Phase I Inspection Report

Rainbow Lake Dam

Upper Hudson River Basin, Hamilton County, NY

Inventory No. NY 18

PROPOSED DAM RECONSTRUCTION

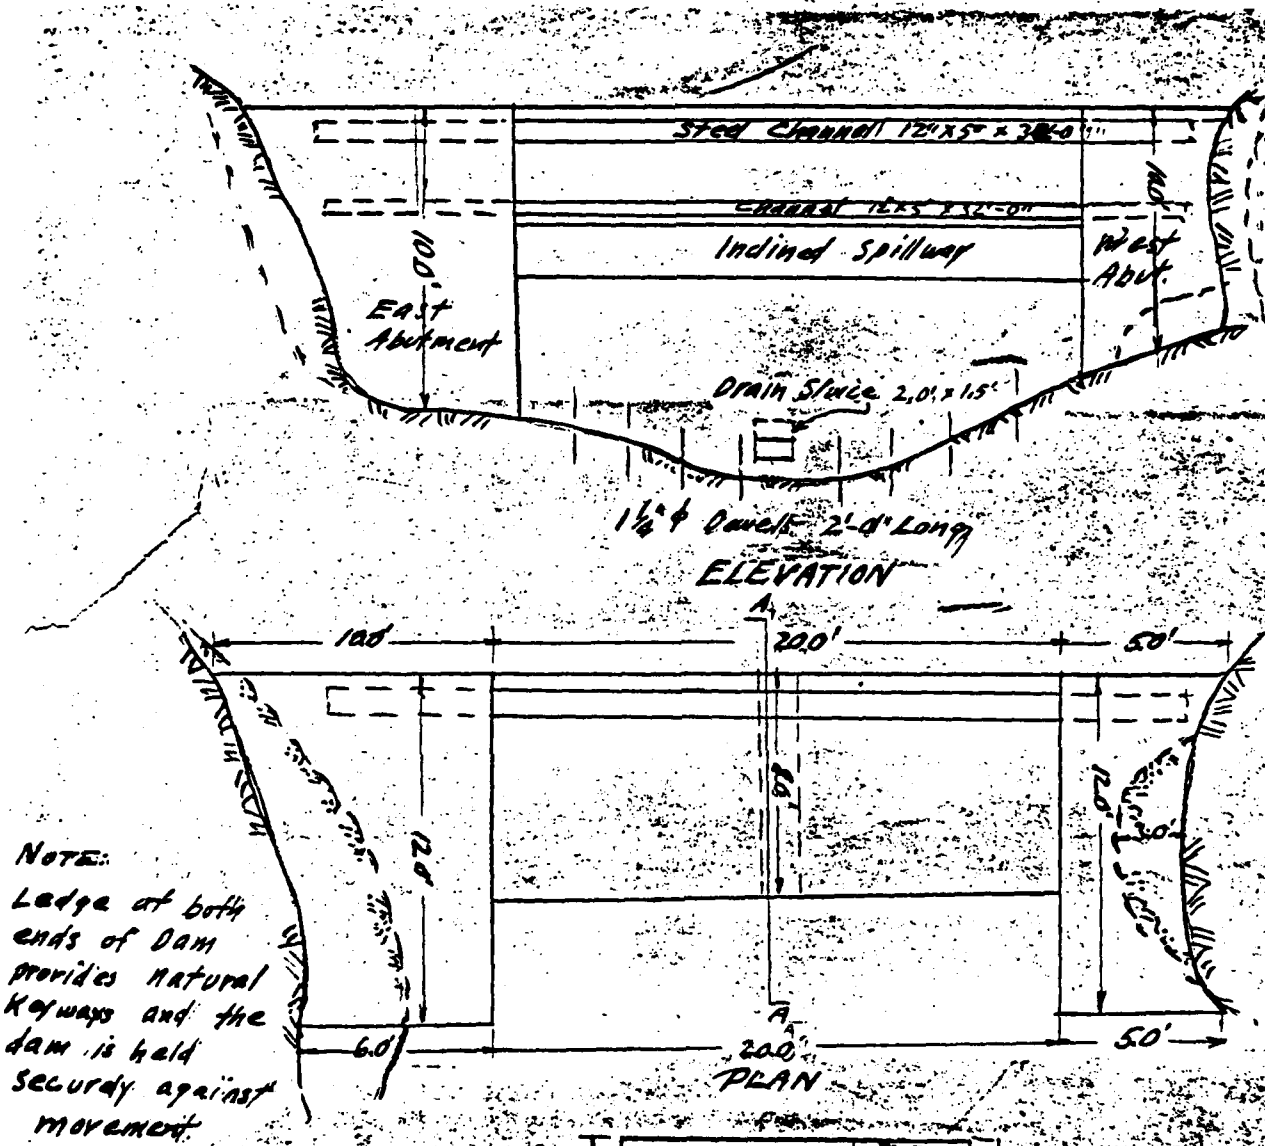
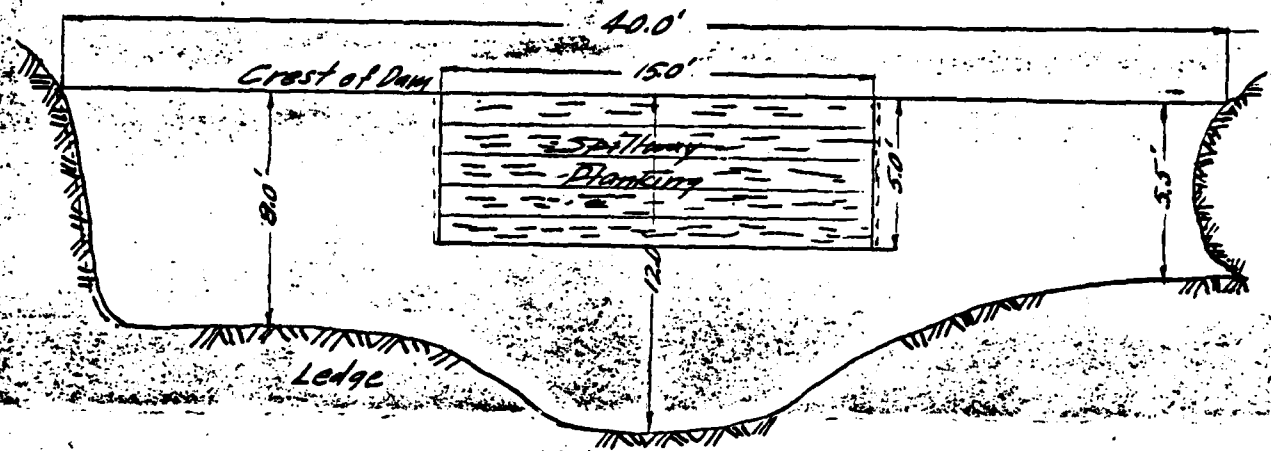
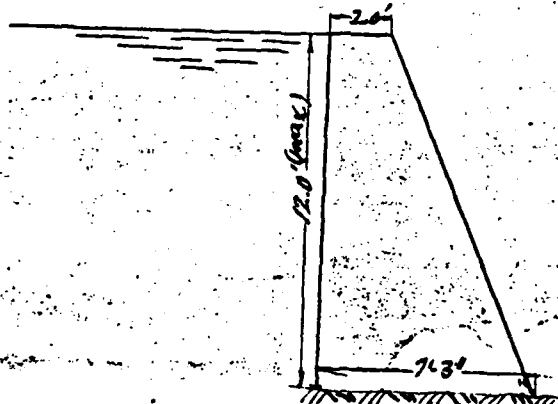
Information which was available concerning this structure was extremely limited. The 1929 sketches of the dam provided some information concerning the structure. However, the dimensions shown on these plans did not agree with measurements made during the visual inspection. Information about the lake was obtained from the 1971 plan of the area prepared by Edward C. Hess Associates, Inc. Due to the limited amount of information available, certain assumptions had to be made concerning both the dam and the reservoir.
